FIELD OBSERVATION REPORT - Bldg #14

Permit No. 18-131555-00 BC
 Owner: Vintage Grand Condo Assn, Inc.
 Project Address: 4017 Crookers Lake Blvd., Sarasota, FL
 Contractor: RL James Inc
 Inspector (s): Mark Boss PM / Mike Jones
 Type of Assessment: Progress

PROJECT NAME:
 WOOD FRAME REPAIRS & RELATED WORK
 VINTAGE GRANDE CONDOMINIUM
 ASSOCIATION, INC.
 4012 CROCKERS LAKE BLVD.,
 SARASOTA, FL 34238

PHOTOGRAPH #1

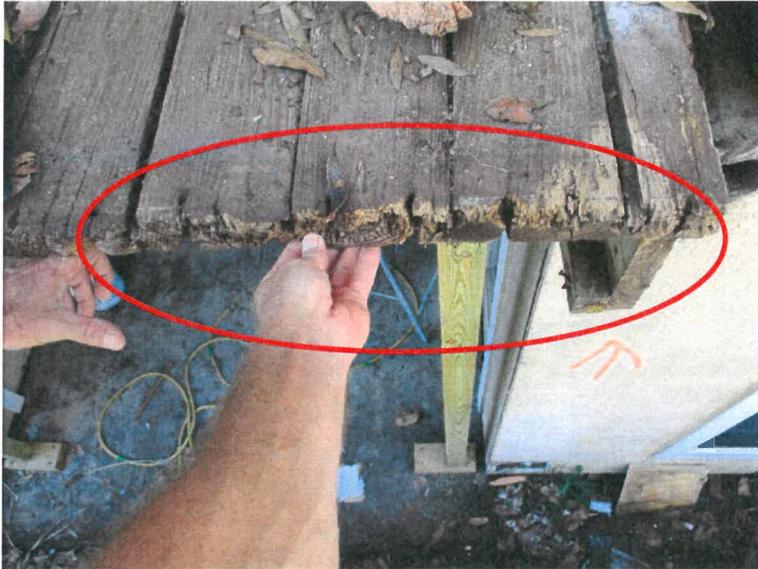
Contractor has removed rails and deteriorated build up beam, exposing areas of repair required as per drawings and specifications.

PHOTOGRAPH #10

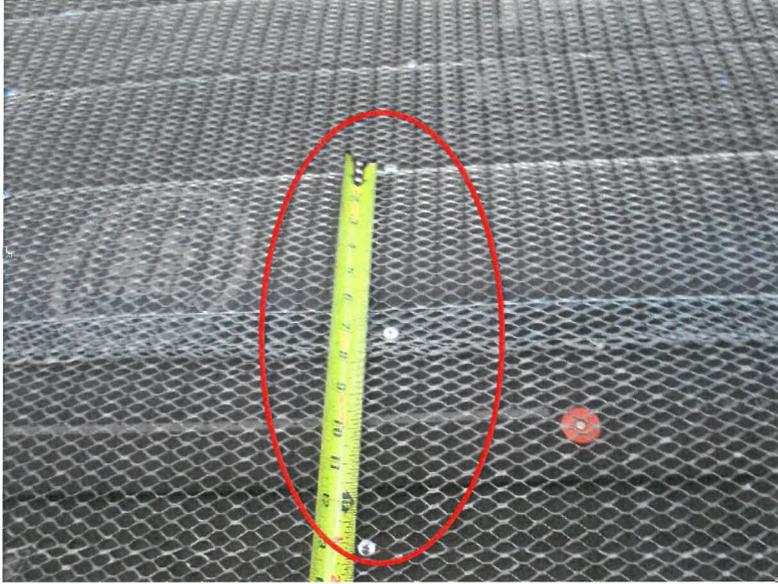
Sub-contractor has installed new PVC accessories and lath per specifications and drawings.
